A REVIEW OF THE MILLSTONE-3 PROBABILISTIC SAFETY STUDY

Abel A. Garcia, Principal Investigator

May 30, 1984

Prepared for
Division of Safety Technology
Office of Nuclear Reactor Regulation
U. S. Nuclear Regulatory Commission
Washington, DC 20555

Figure 3.4.16-2 Fault Tree Model of Loss of Vital DC Bus

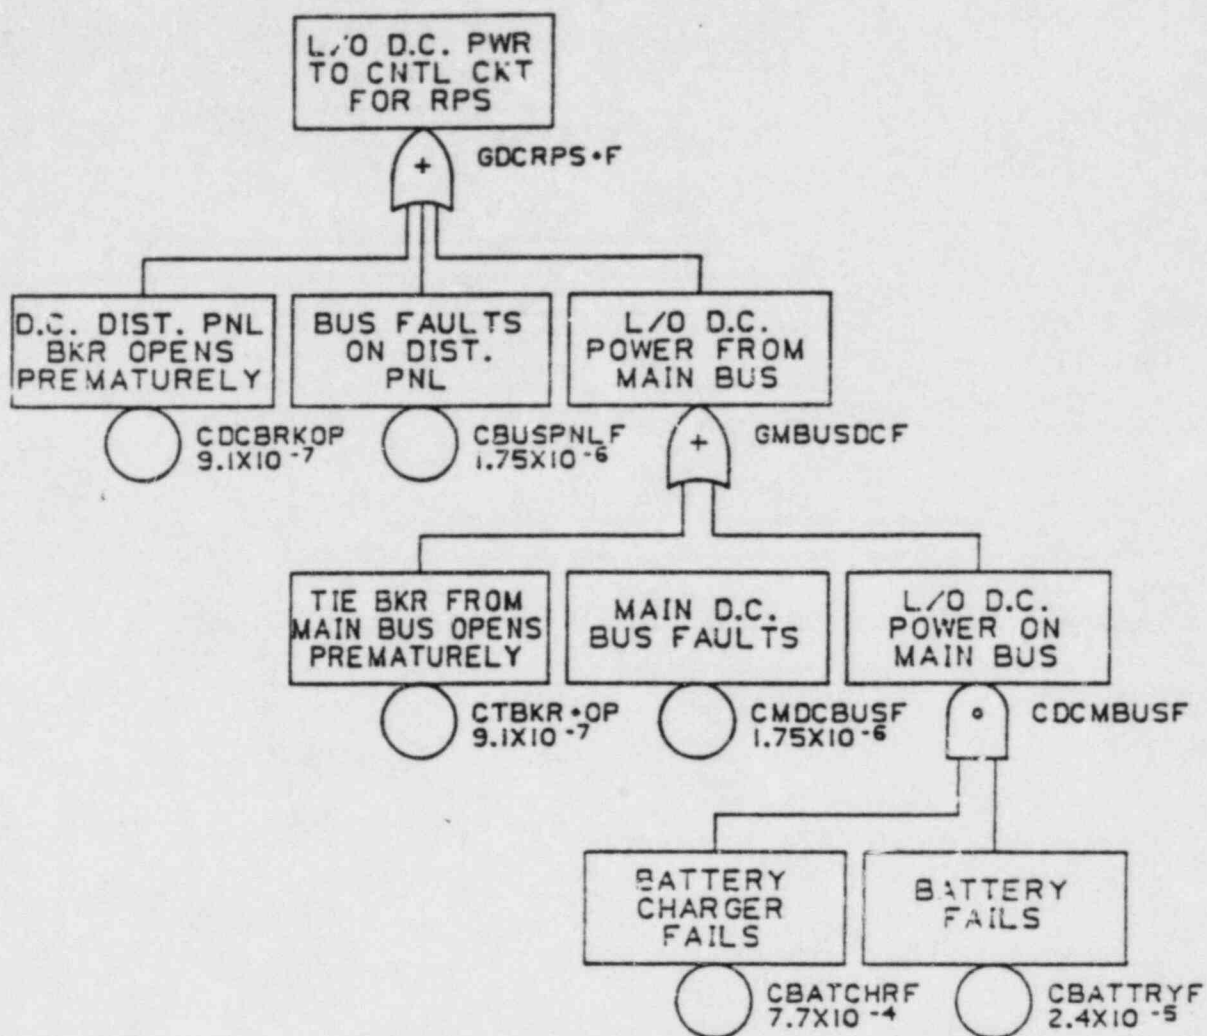
The system fault tree model was used to quantify the frequency of failure of a single dc bus and the frequency of total dc power failure. The fault tree model including the 24 hour mission failure rates is shown in Figure 3.4.16-2. The fault tree calculation provided a failure probability of 5.36×10^{-6} /day for losing a single bus. The frequency of losing any one of the two most critical DC buses (125 - VDC-1 and 125 - VDC-2) was quantified by doubling the failure probability of a single bus. This gives a failure frequency of 3.91×10^{-3} /yr for losing one of the two critical buses.

Our major concern involves the failure of the fault tree to model the unavailability on demand, given that there has been a loss of offsite power. The fault tree (figure 3.4.16-2) models the availability of dc power given that ac power is available in the vital ac. The structure of the tree does not allow the determination of dc unavailability given loss of offsite power. During the first few seconds of this event the portion of the vital dc system that includes the batteries and the components that transmit power from the dc bus to the vital ac bus and the EGLS is a crucial subsystem whose failure could rapidly lead to potentially serious damage states (see Section 3.4.4).

Figure 3.9-1. MP-3 PSS Diagram of RHR Suction

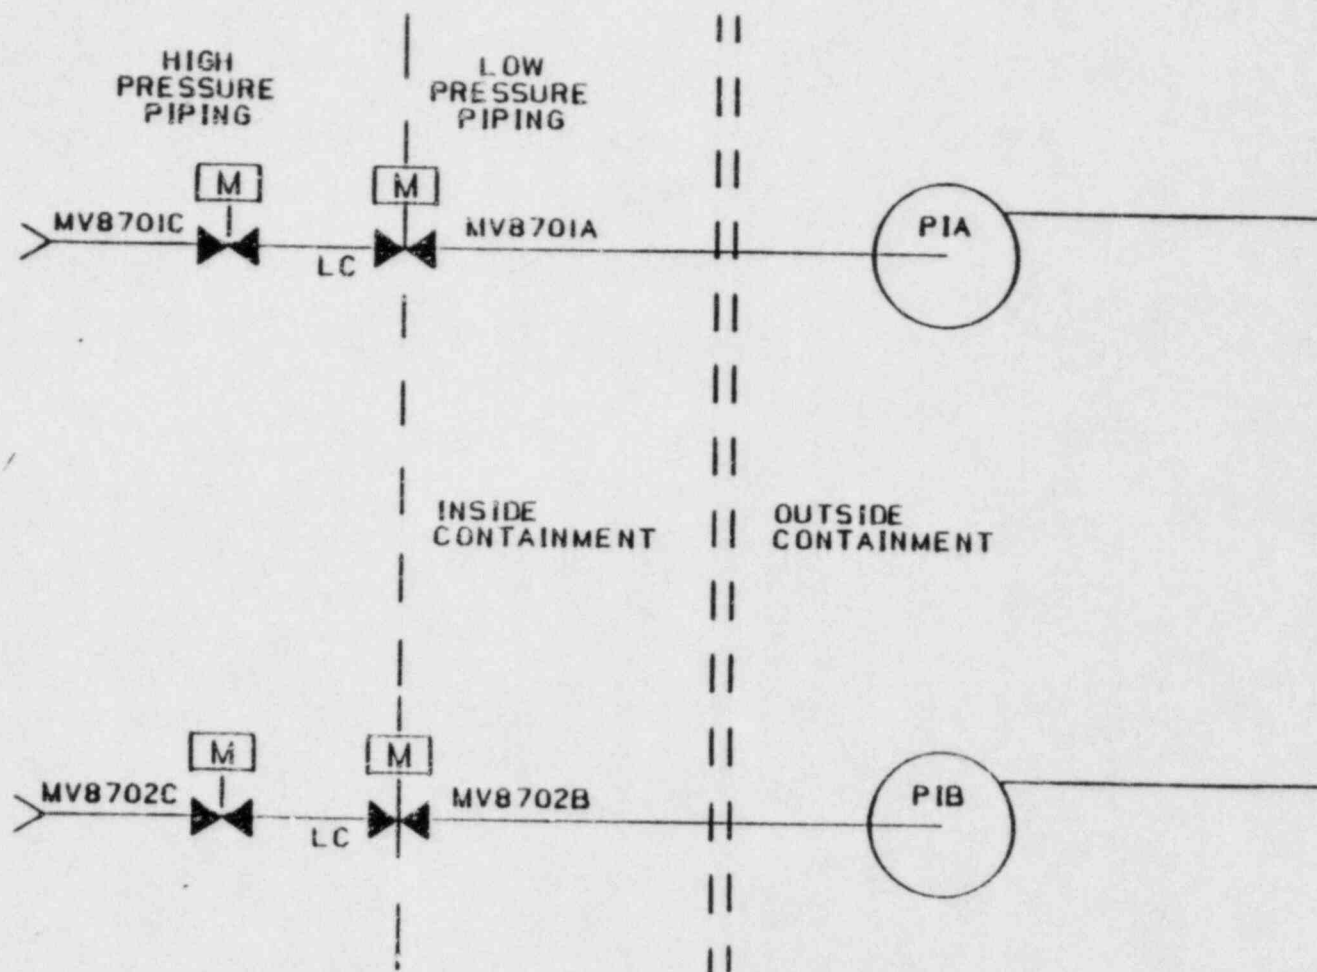
- a. There appear to be discrepancies in the pipe and valve configuration assumed in the PSS for the RHR suction. This portion of the RHR system was found to dominate the probability of a V-sequence accident. The assessment of the V-sequence probability for this case is provided in Section 1.1.2.1.7 (Vol. 2) of the PSS. The configuration used in the assessment is reproduced as Figure 3.9-1.

According to the Section 1.1.2.1.7 description, the accident would occur upon failure of both valves in either pump suction line. The transition from high pressure to low pressure pipe is shown on Figure 3.9-1. Thus, rupture could occur inside the containment, but this is conservatively assumed not to occur in the PSS. (Rupture inside containment would not lead to severe offsite consequences since the containment barrier is not breeched.

Figure 3.9-2. MP-3 Simplified RHR System from S&W Drawing No. 12179-EM-112A-1 (4/14/82)

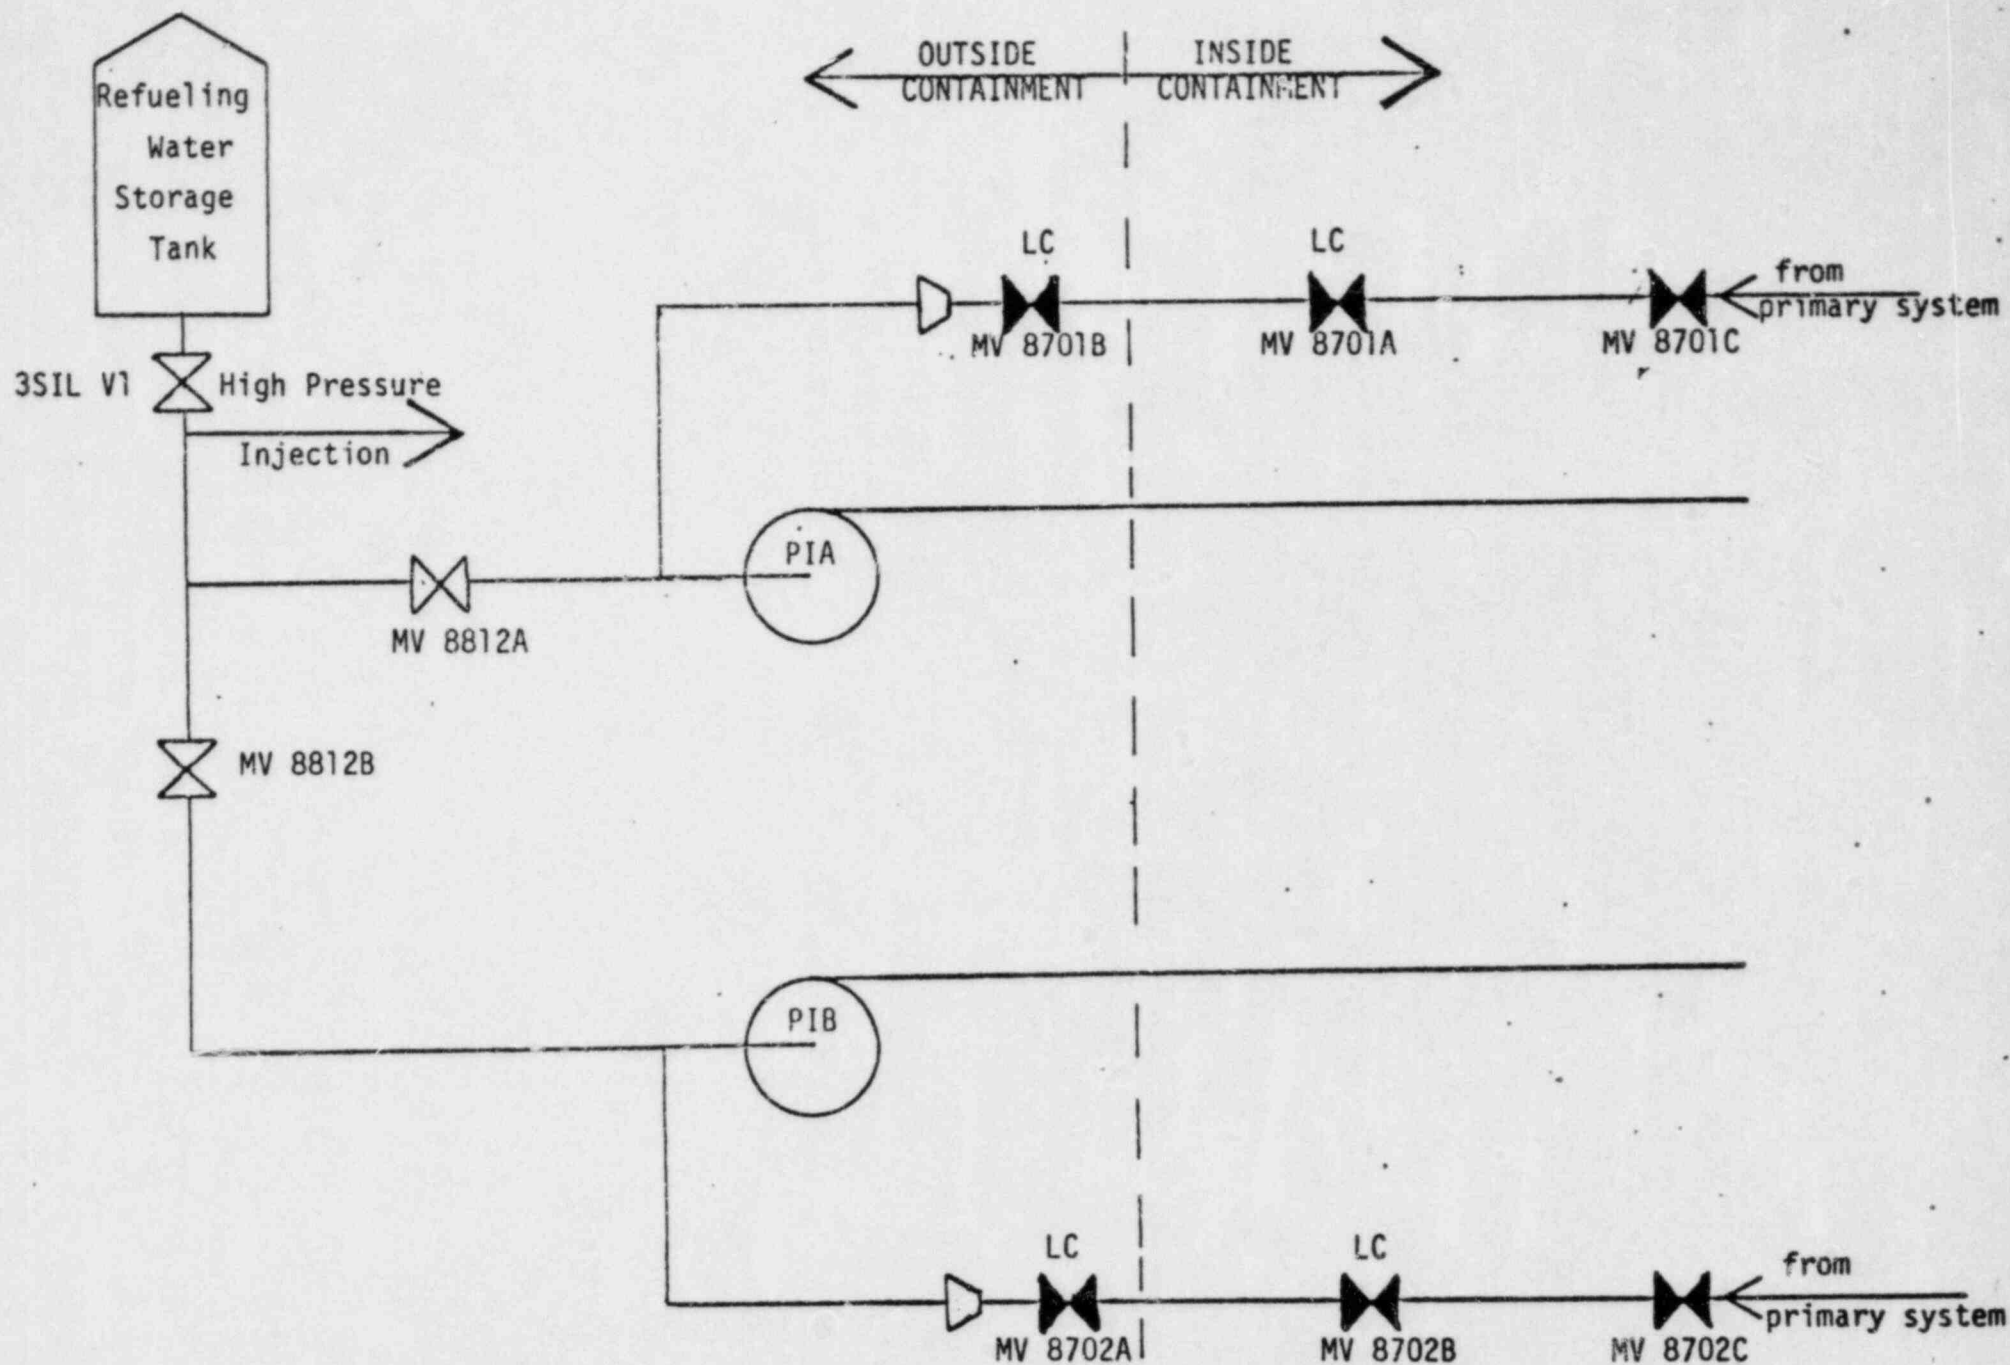
Based on an actual P&ID drawing (S&W drawing #12179-EM-112A-1), Figure 3.9-2 has been prepared. This drawing indicates that a third valve (MV8702A and B) exists in both RHR suction lines. Based on other plant designs, it seems likely that the transition from high to low pressure pipe would occur at the location of these valves rather than inside the containment. If this is the case, the probability of the V-sequence accident would be reduced dramatically since a third valve, normally locked closed, would have to fail. (The S&W drawing does not indicate the design pressure transition point.) If low pressure pipe is located between the inside and outside valves (as implied by the PSS assessment), then there is a possibility of a rupture outside containment. However, depending on relative pipe segment lengths inside and outside the containment, the probability of an outside rupture would be reduced over the PSS value.

Figure 3.9-3. Example Event Tree for V-Sequence

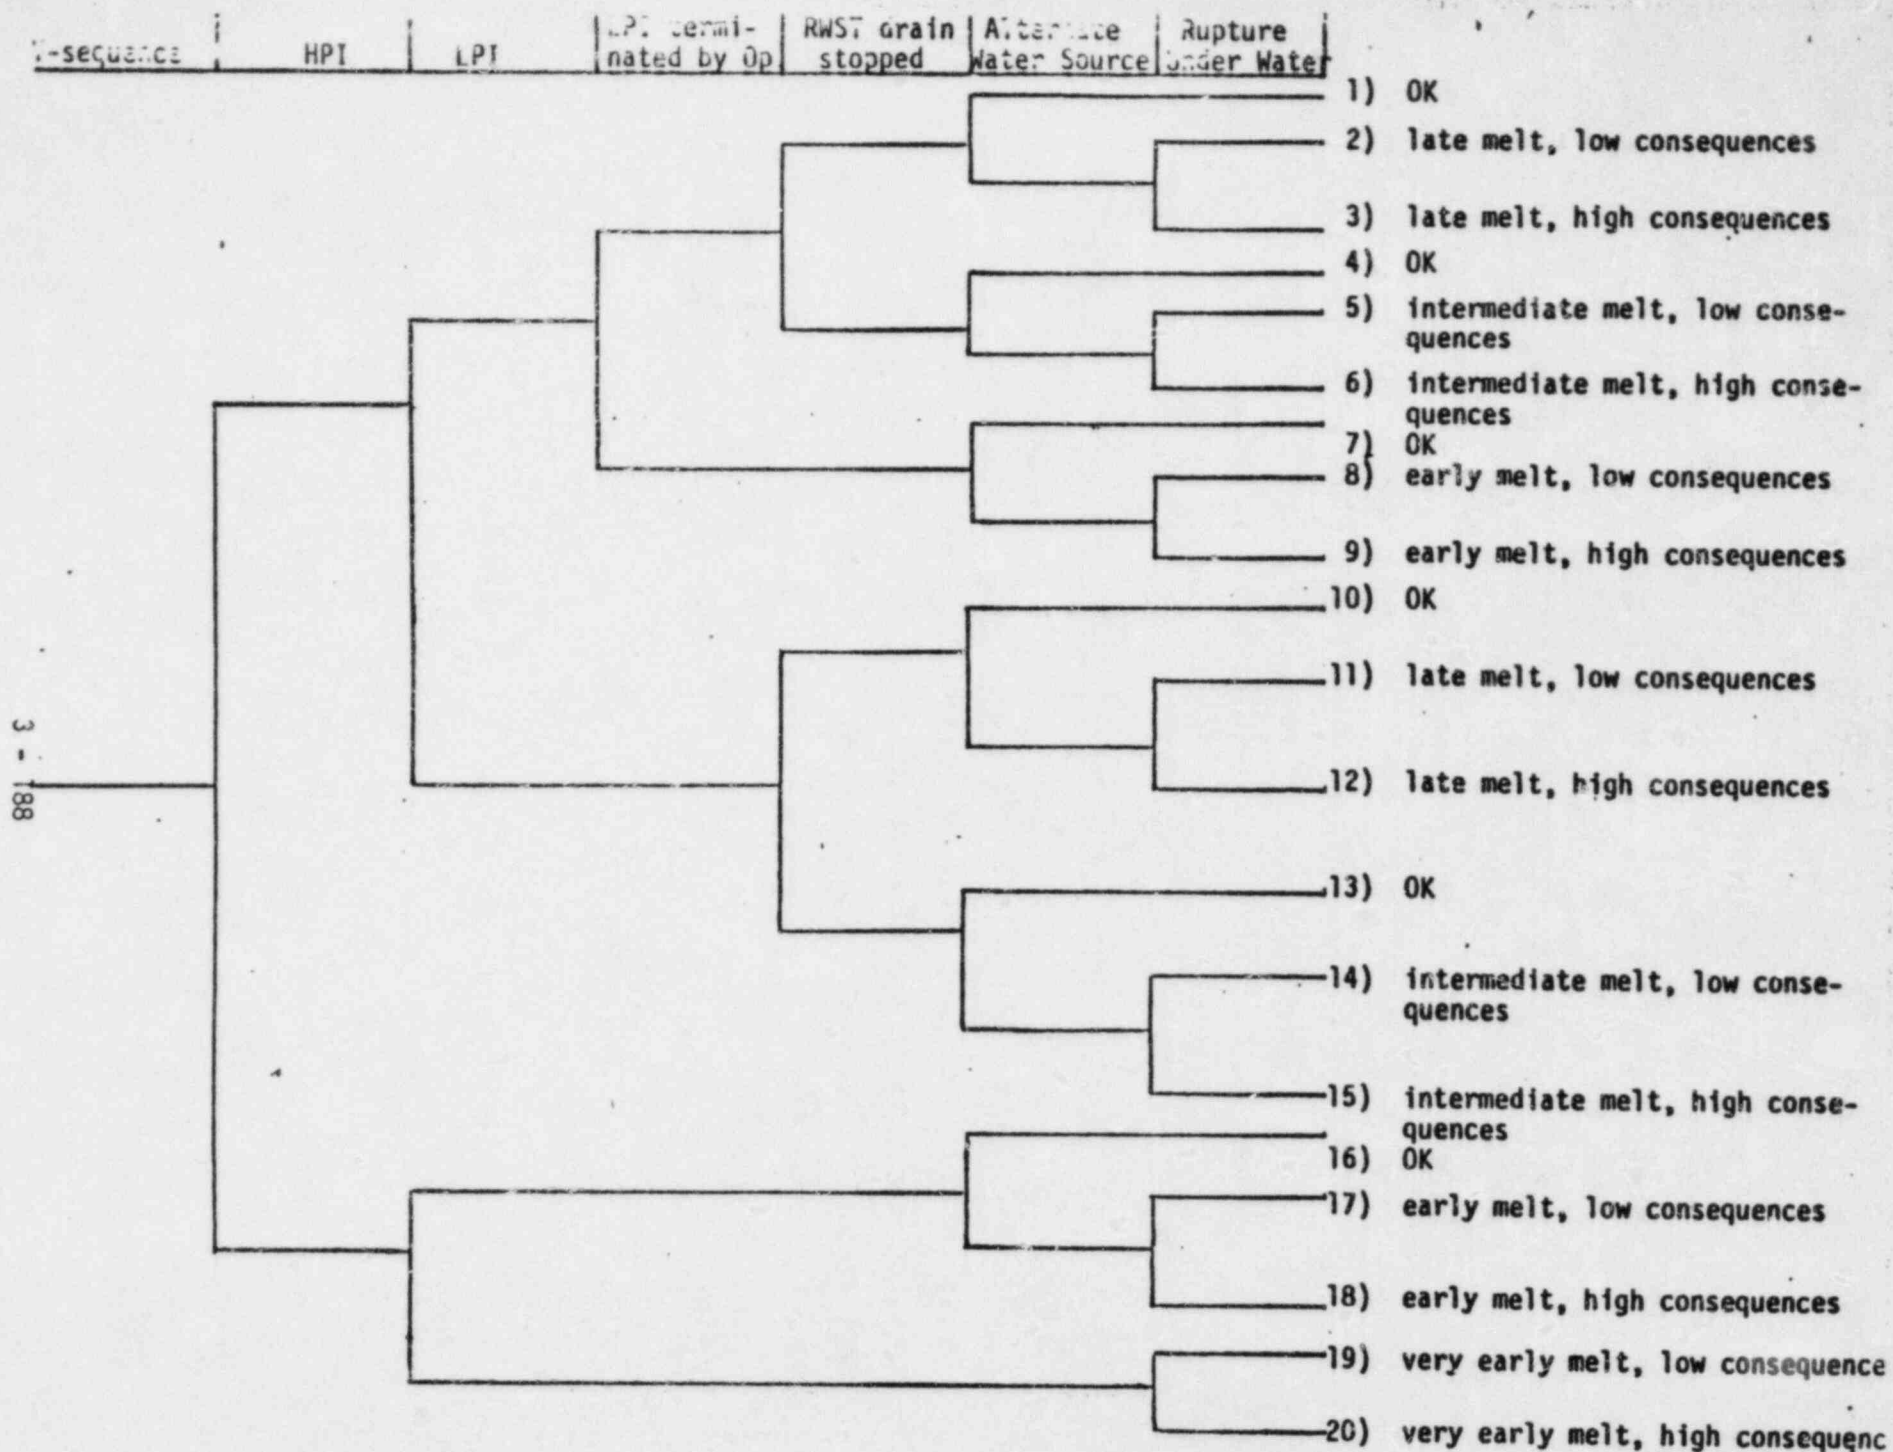
The preceding discussion suggests that the V-sequence accident is a complex event with many possible outcomes depending on assumptions made and operator actions taken. Figure 3.9-3 qualitatively depicts these alternatives in event tree format. As indicated by the figure, some 20 different outcomes appear feasible. Of these 20, some 17 would appear to result in lower offsite consequences (and therefore lower risk) than assumed in the PSS due to either sustained core cooling, delayed melt, or removal of radionuclides from a submerged rupture. The only scenario apparently considered in the PSS is No. 9 in Figure 3.9-3. Quantification of the event tree in Figure 3.9-3 would require additional effort and detailed knowledge of plant design features.

Figure 4.1-1 Possible Ground Motion Models for the Eastern United States

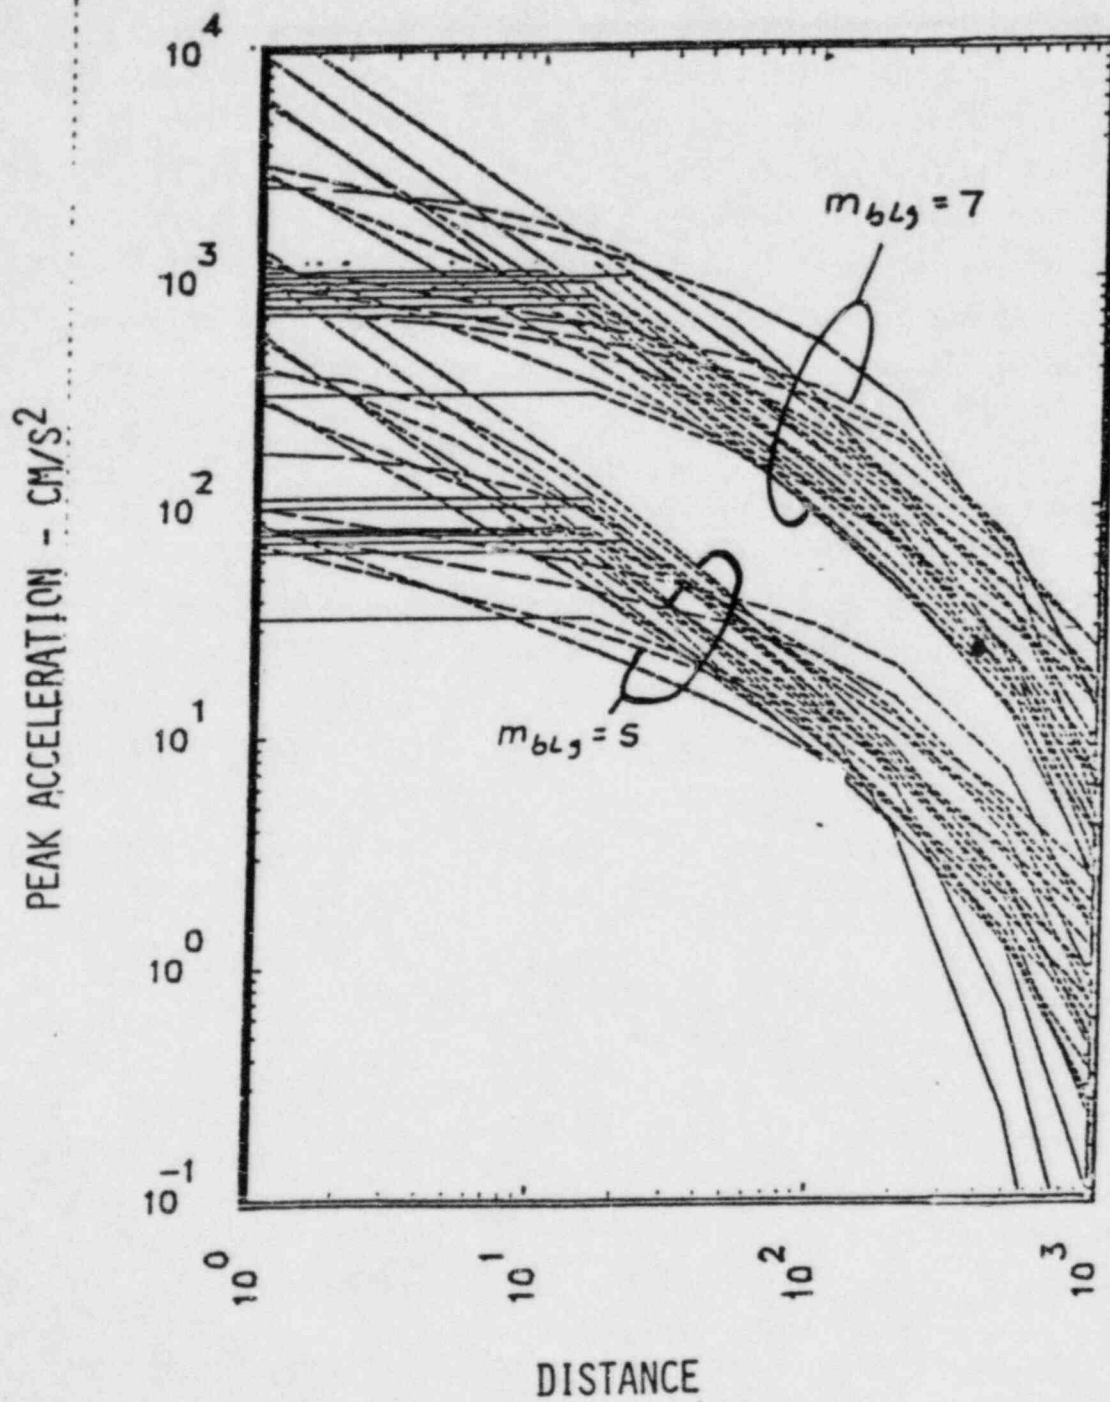
The other model used is the Campbell model. It is a reasonable model similar to the Nuttli-Herrmann model. However, neither the Nuttli-Herrmann model nor the Campbell model are based directly on EUS data. In fact, both were derived using the same set of semi-theoretical assumptions. We therefore find it surprising that none of the many other approaches to developing EUS ground motion models (e.g. see Bernreuter (1981a)) were used. Figure 4.1-1

shows a comparison of the results from a wide variety of models that use various acceptable alternatives. By acceptable, we mean that the methodology/data used to arrive at the model is reasonable and (at least for the set of models compared in Figure 4.1-1) at least one member of a panel of experts in modeling of EUS ground motion deemed the model a possible alternative. See Bernreuter et al. (1984) for further discussion. This figure, which shows peak ground acceleration vs epicentral distance for the magnitude values of 5 and 7, illustrates that there is considerable uncertainty in the ground motion modeling process and supports the point that the +20% factor used in the D&M analysis is low. The models used in the D&M study are (in our opinion) two of the "better" EUS ground motion models. But as noted in Section 4.1.2 one element of a probabilistic analysis is to ensure that the uncertainty has been bounded and included in the analysis. This has not been accomplished in the D&M selection of ground motion models.
